HINCKLEY NATIONAL RAIL FREIGHT INTERCHANGE

Project reference TR050007

SoCG between the Applicant and Leicestershire County Council

Document reference: 19.3

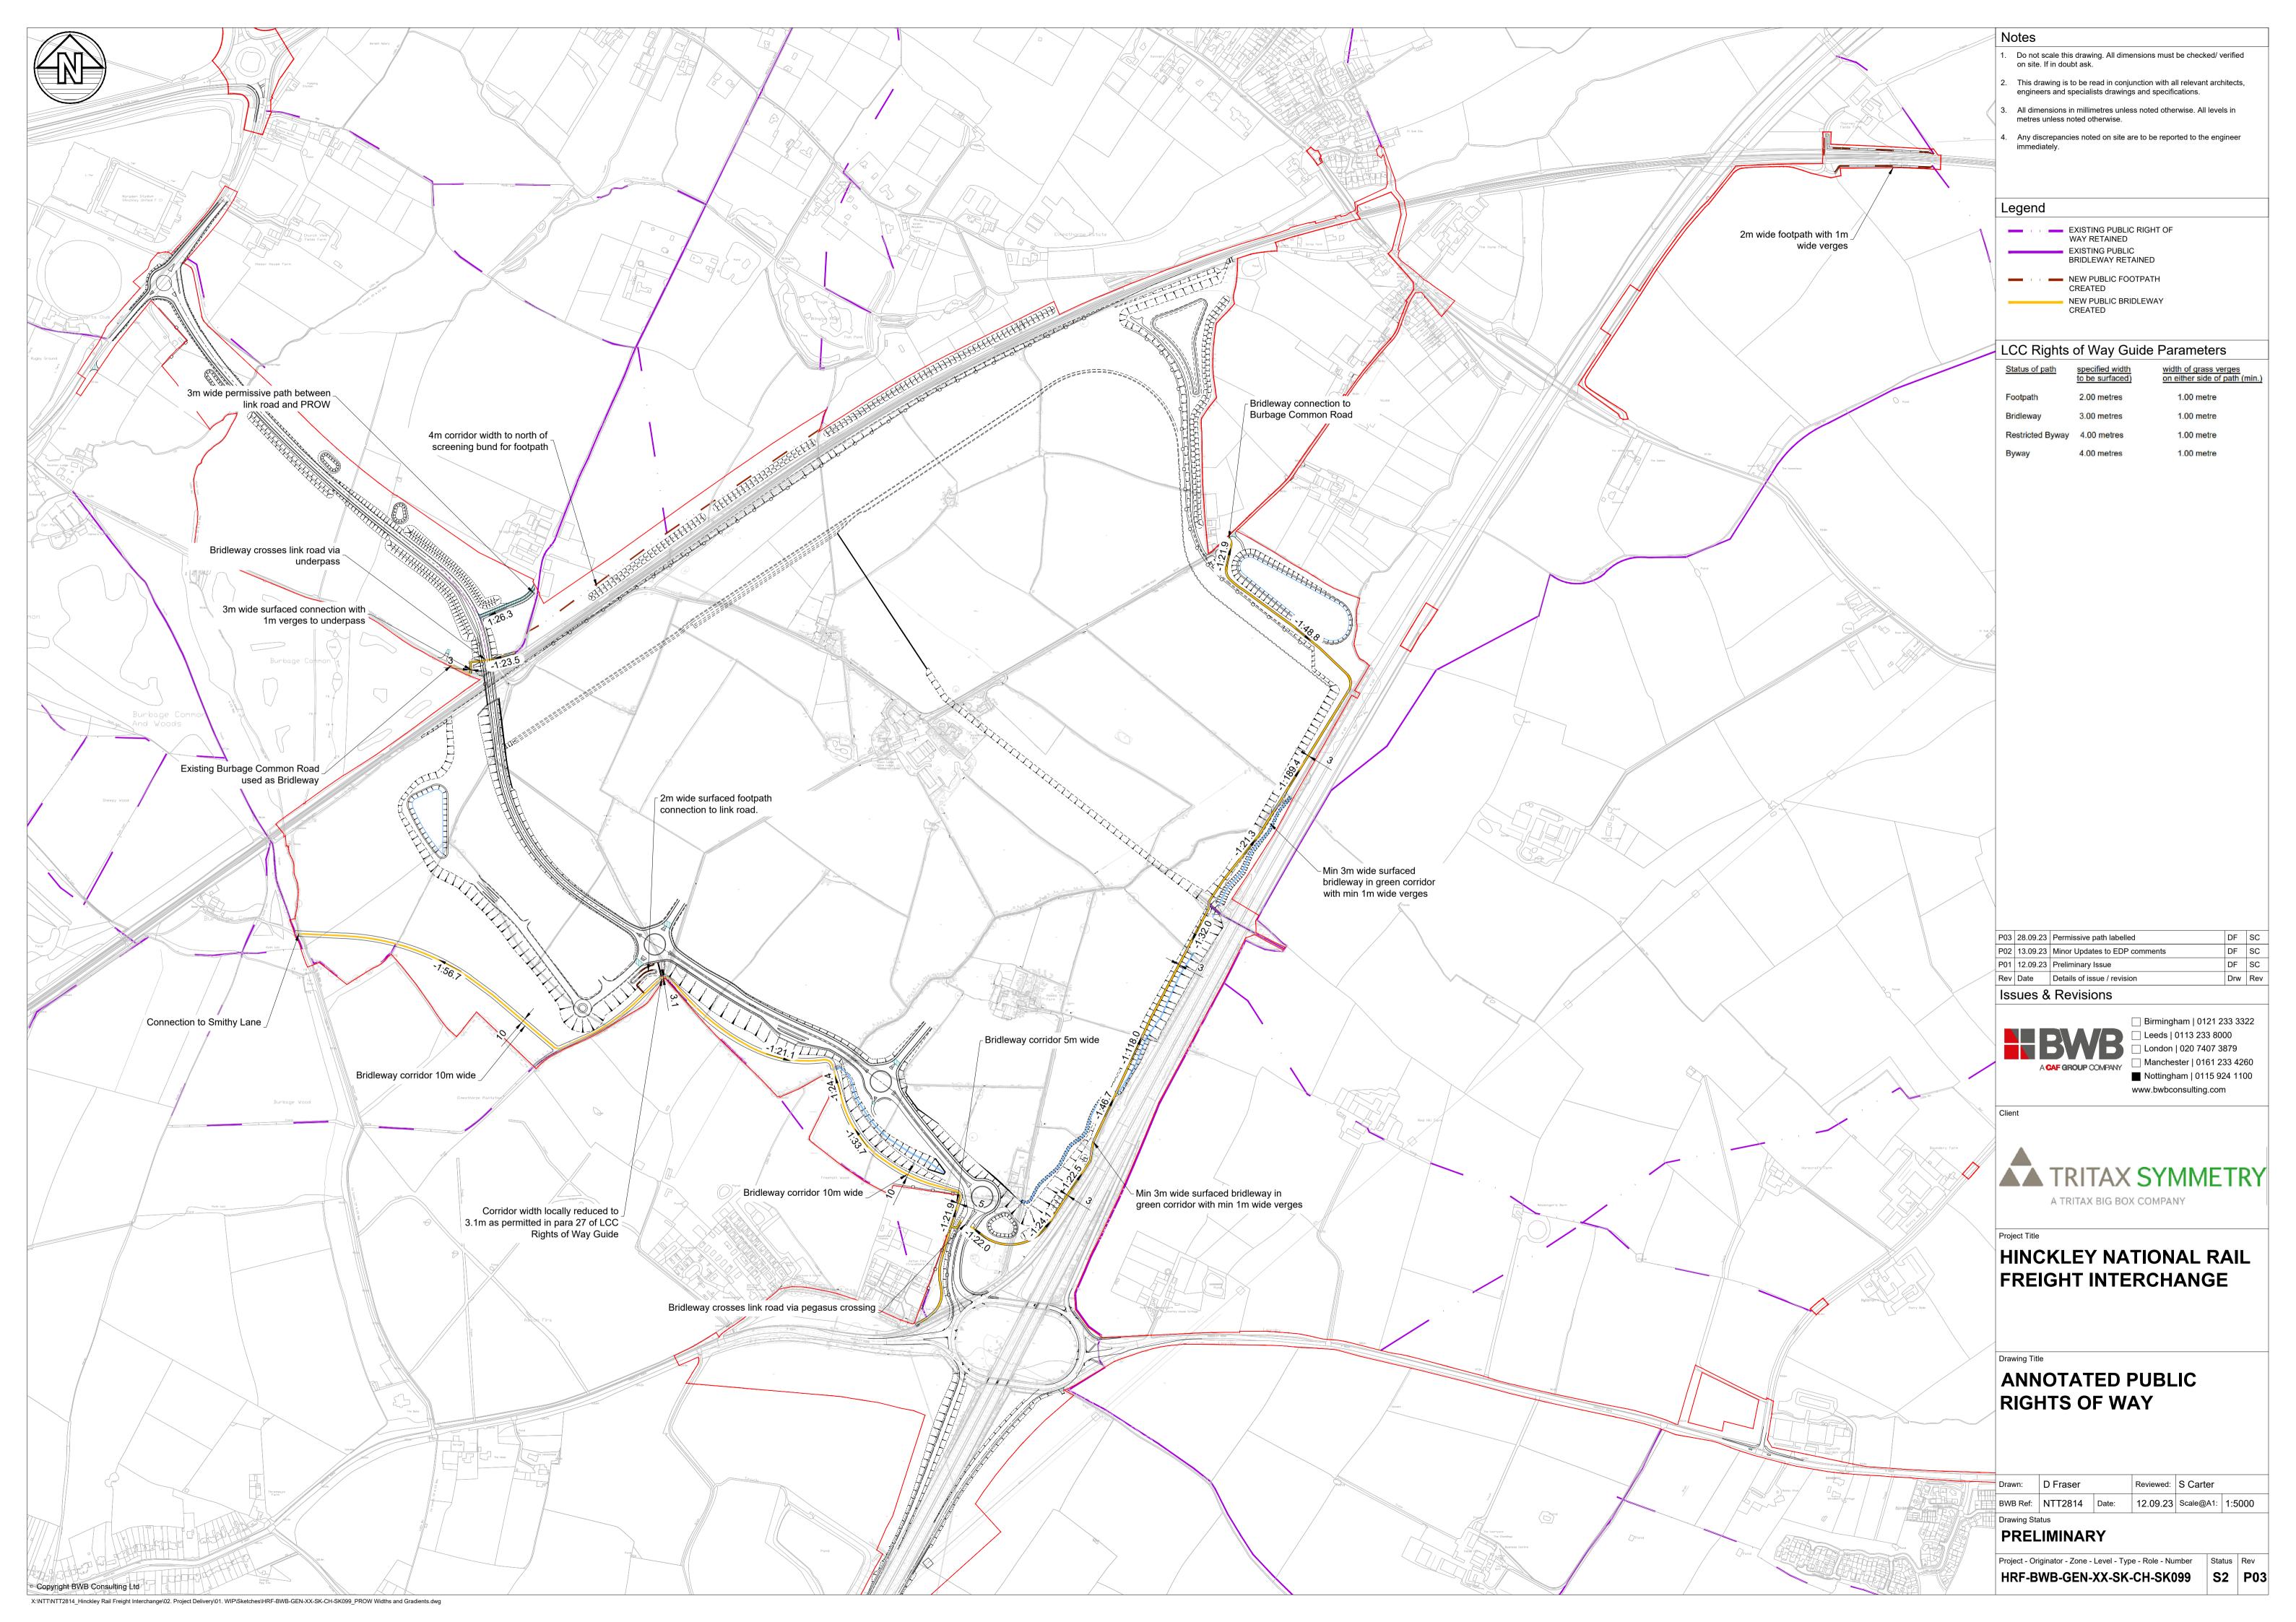
LCC Comments Applicants Response	LCC Response	Applications further response
General comment – missing details of widths, surfacing, gradients, fencing etc. Therefore, unable to confirm if alternative routes proposed are acceptable. We have generally allowed a minimum width of 3m for new/diverted public rights of way. Where space allows, we have provided wider corridors for verge strips, land drainage, fencing etc. and would propose that we agree the details of these at the detailed design stage. Similarly, surfacing materials and requirements for fencing will vary depending upon usage and location, and will be subject to detailed assessment and consultation with LCC. We would therefore look to agree these as part of the detailed design process. Gradients of new PRoWs are designed to be as gentle as possible and generally no steeper than 1 in 20. If there are any particular areas of concern, we are happy to look more closely, but in general would welcome the opportunity to discuss the geometric design	I am afraid that the assumptions made in respect of widths do not accord with the Leicestershire Highway Design Guide (see Appendix). The minimum width for PRoW provision is 4m (2m surfacing with 2 x 1m verges), increasing to 5m for bridleways. When we met, Fiona mentioned that there were drawings available in the application submission that showed further details. I would be grateful if these document references could be provided as we have been unable to locate them. As we discussed, whilst the specific details of the PRoW can be finalised at detailed design stage (albeit we cannot find that this is covered by a requirement given that the only reference is to the PRoW Strategy which does not appear to provide any reassurances on design parameters) we need to be	Requirement 4(2)d Detailed Design Approval covers this matter, details of cycle tracks, footpaths and bridleways, including highway crossing points for pedestrian, bicycle and equestrian traffic must be submitted. Please find attached annotated PROW plan to confirm that the proposed new and diverted PRoW can be delivered to standards.

of PRoWs in more detail during the detailed design process.	be diverted, the diverted route can be delivered to standards. To date we have not seen any information to demonstrate that is the case, and can find no commitment in the application submission to specific design parameters.	
<u>U52</u> No details provided of proposed underpass – suitable for equestrian use?	The underpass will be suitable for equestrian use. We are in the process of producing a plan and section of the proposal and will issue this as a sketch in due course.	We look forward to receiving the details of the underpass for review.	Please find attached plan showing the underpass.
Is there proposed to be a direct connection to the link road?	Please refer to ES Figure 11.14 which shows connectivity to the link road via a permissive path from U52	ES Figure 11.14 appears to refer to "Site Character and Context":	Figure 11.14 is the Public Rights of Way Strategy, figure 11.4 is Site Character and Context.

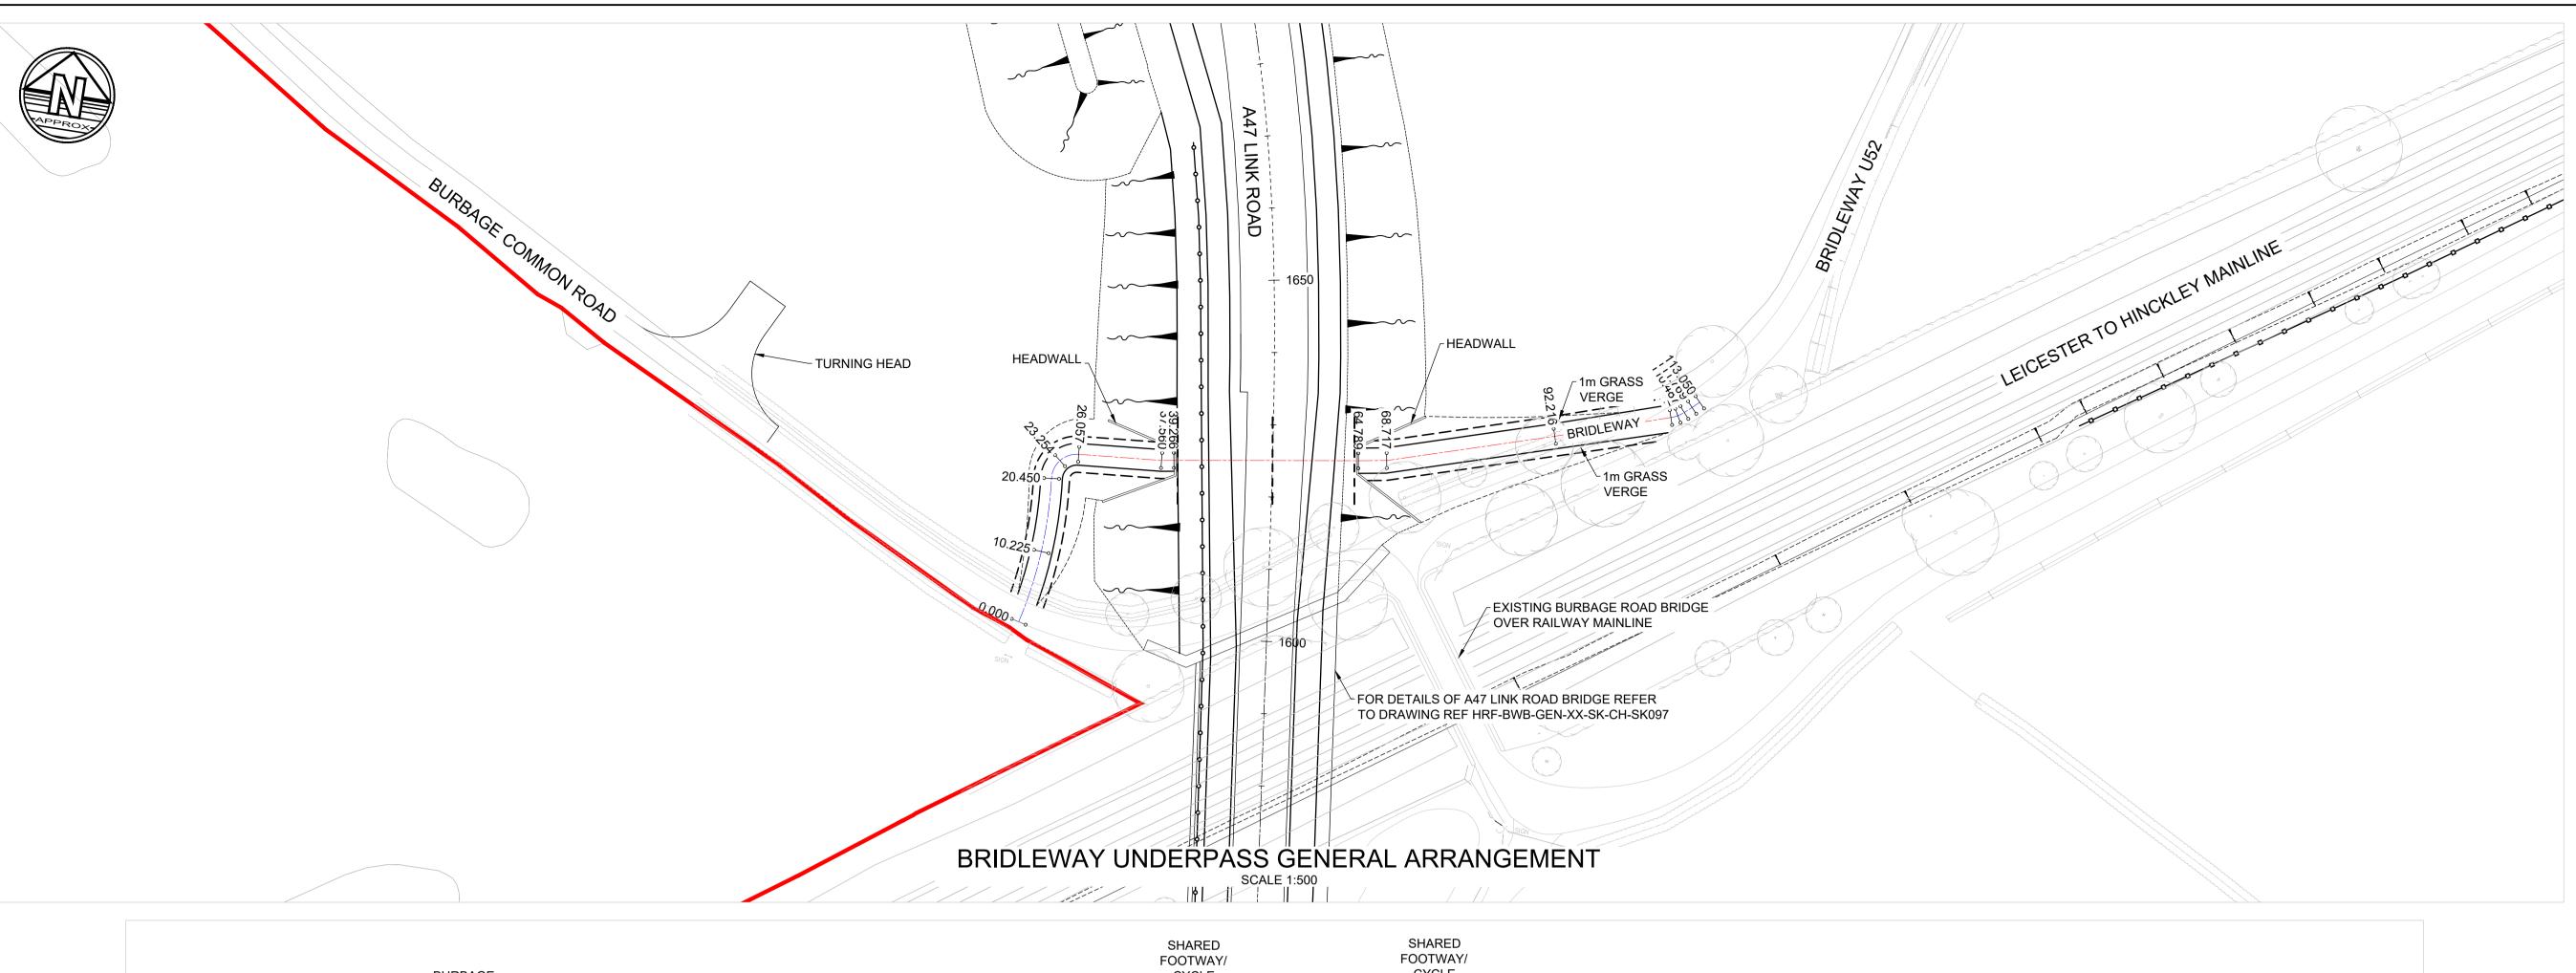
This does not include for the link road or PRoWs. As we discussed when we met, we cannot find a drawing that demonstrates that a connection is deliverable given level differences between the PRoW, the link road, and given the constraints of maintaining the existing private access. Please	As noted above the plan that was referred to illustrates the permissive path, we do not have a PRoW link. The annotated PROW plan that we have produced illustrates this link, its width and that the longitudinal gradient is suitable.

can you provide the drawing reference that demonstrates this?	
V35/1 This should be stopped up inside red line boundary where duplicated by proposed bridleway.	Stopping up V35/1 within the red line would leave sections outside of the red line with no connectivity. It is therefore not proposed to stop any of this right of way up as it is not affected by the proposed works.	In which case, we will agree to disagree, and our concerns remain in respect of the enclosure of the PRoW with acoustic fencing, and the duplication of routes for future maintenance.	There is not a duplication of routes, the existing PRoW gives access to Freeholt route on a public footpath through Aston Firs and direct access for Aston Firs Residents. The new route provides bridleway access north of the woodland. The plan below illustrates how PRoW V35 would pass through the acoustic fence in accordance with LCC PRoW Standards.

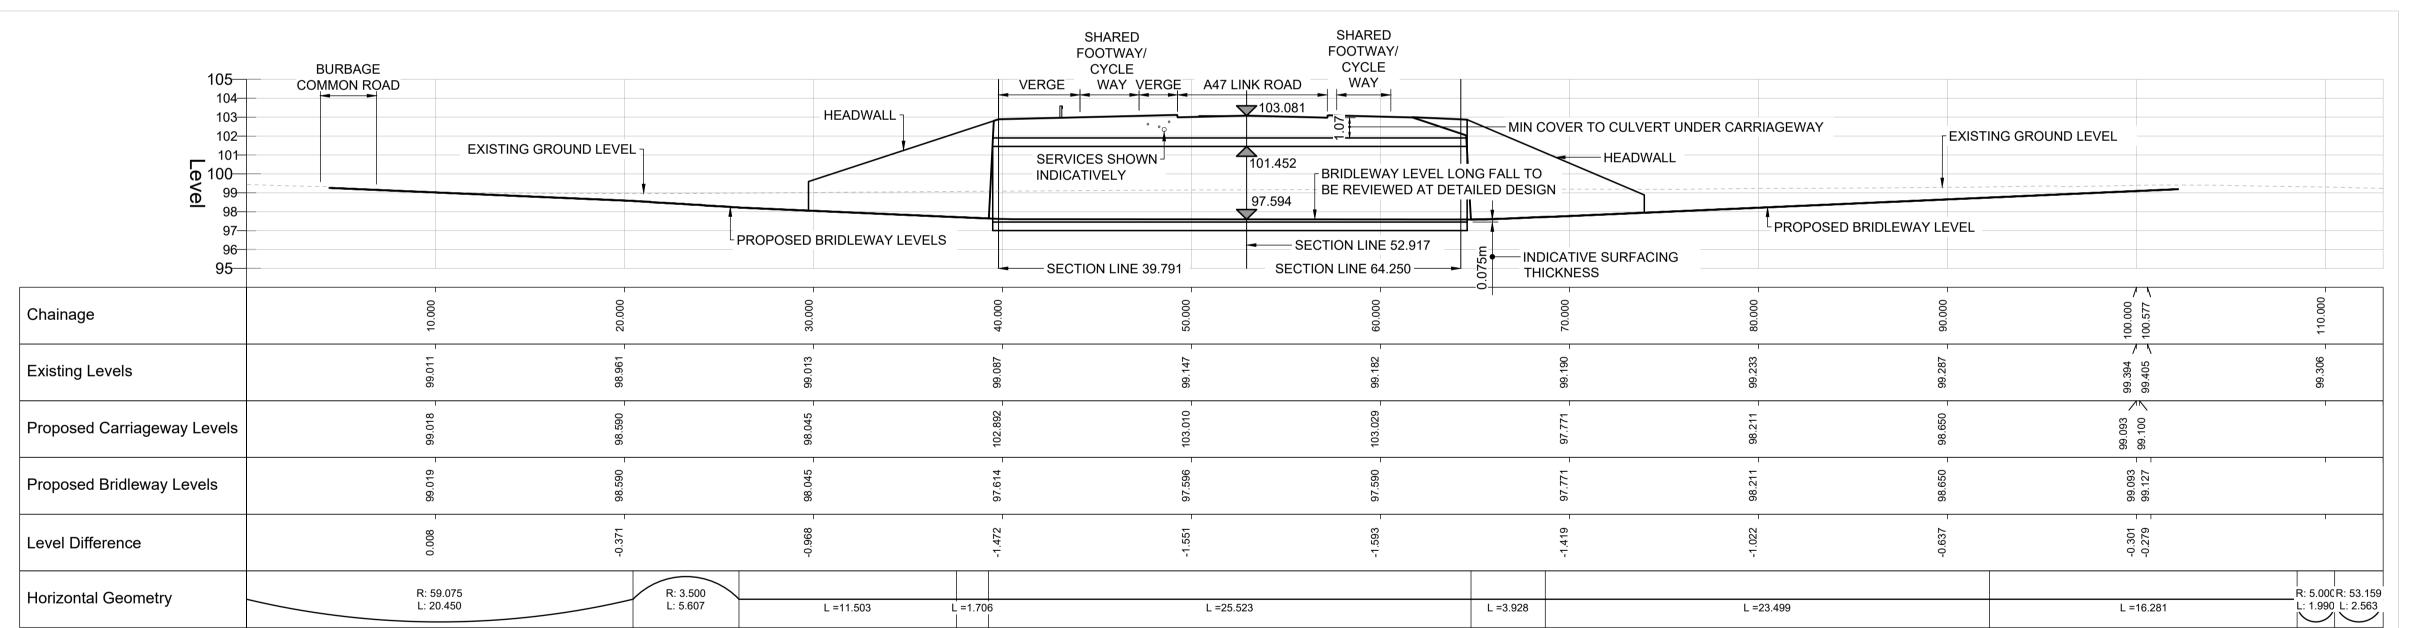
Railway crossings			
Footpath diversion is 440m, current route is 20m. What is the justification given the distance from the development? Who owns existing bridge structure and where does the responsibility rest for future maintenance?	The Thorney Fields Farm is at a distance from the site, however Network Rail have identified Thorneyfields Farm level crossing as a directly affected crossing for the reasoning that a situation could arise whereby a 775m train may have to wait nearby on the mainline to enter the terminal. A waiting train on the mainline could block views of trains coming in the other direction at speeds of up to 90 mile per hour,	Thank you for the clarification. Please can you point us to the documents that confirm Network Rail ownership and future maintenance responsibility.	Land Plan Sheet 2 of 8 identifies plot 55 which is the bridge over the railway line. The Book of Reference confirms that Network Rail own and occupy the bridge. As the bridge is a Network Rail asset which they both own and occupy it is their responsibility to maintain their asset.

Network Rail have determined a safety risk is present whereby a pedestrian may attempt the crossing in this situation. The existing bridge structure is in the ownership of Network Rail and future maintenance for the bridge will continue to rest with Network Rail.		
T89/1 – Elmesthorpe Alternative provision inadequate (narrow footpath over Station Road bridge).	The alternative provision is via highways maintained footways utilising Bostock Close, a proposed crossing point over Station Road and the footway on the south western side of Station Road over the railway bridge. This is a well used route and considered to be a much safer alternative to either the level crossing or the stepped access onto the north eastern side of Station Road Bridge which requires the use of a stile and for users to climb over a safety barrier onto a narrow hardened verge and the use of the south western footway to cross the railway bridge. The Surveillance Group Ltd. was commissioned by Network Rail to undertake a 9-	When we met Fiona stated that a Road Safety Audit/Assessment had been carried out of the diverted route, please can you arrange for this to be forwarded. For the benefit of doubt, consideration is not just in respect of existing users of the PRoW, but future users particularly since the submitted Sustainable Transport Strategy relies on PRoWs to provide walking connections to the site.	We have undertaken a risk assessment on the alternative route provided in replacement of the closed section of this PROW and we consider that our proposal is considerably safer than the current arrangements for crossing the railway in this location. Our proposal removes a level crossing as noted in red above, as well as the arrangement on the B581 bridge which has a stile over a section of steel safety barrier. Instead, we are encouraging users to utilise existing footways alongside the public highway and providing a crossing point with tactile paving to cross the B581 (not currently available for either users of footways or PROWs). Given that

BRIDLEWAY UNDERPASS LONGSECTION SCALE: H 1:200,V 1:200. DATUM: 95.000 (TAKEN ALONG BRIDLEWAY CENTRLINE ALIGNMENT)

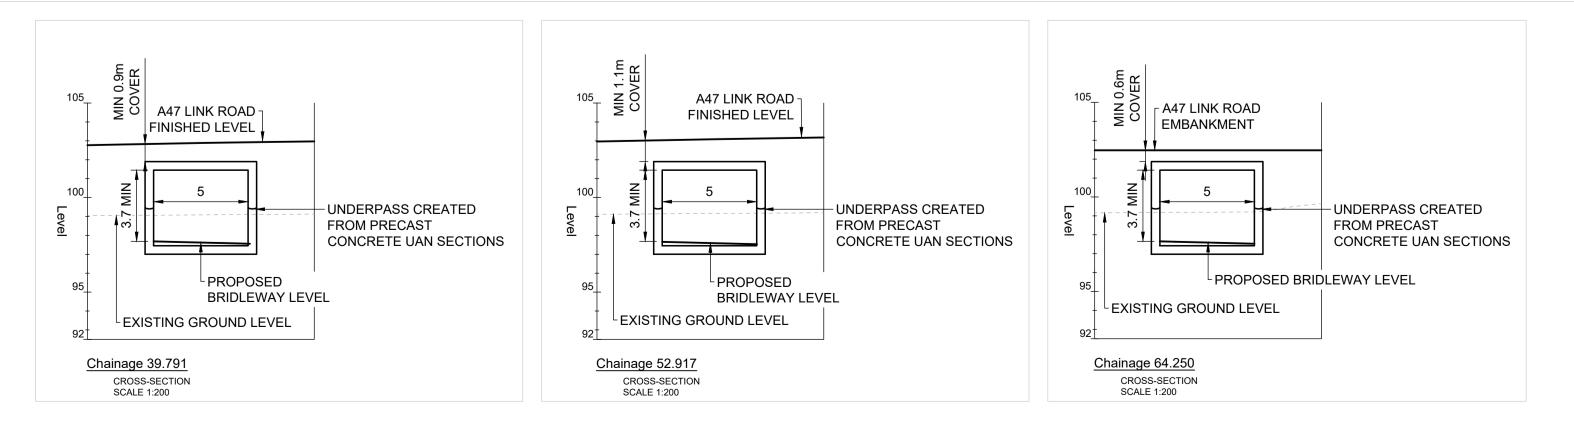
U8- Outwoods No details of proposed structure provided. Who will adopt the structure and be responsible for its ongoing maintenance (NR have said in their RR they will not). This is not something that LCC will consider adopting.	Work is ongoing with Network Rail to determine the design of the bridge; the bridge however will be to a Network Rail specification. The relevant representation made by Network Rail suggesting that LCC Highways take on the bridge is acknowledged however it is expected that this would be a	Thank you for the confirmation. We assume that the bridge design parameters will be set out in a requirement, and Network Rail's future responsibilities will be covered in the DCO? Please can you clarify.	4(2)a covers the matter of Detailed Design Approval for rail infrastructure, Network Rail are currently engaged on the design of this bridge. Network Rails future responsibilities will be covered by Network Rail's Network Licence.

Question deliverability noting	Network Rail asset and this point	
restricted access route and	has been reported to Network	
limited red line boundary.	Rail. Details of the deliverability	
	of this bridge is contained at	
	Appendix 1.1 of the CEMP	
	submitted as part of the DCO	
	application.
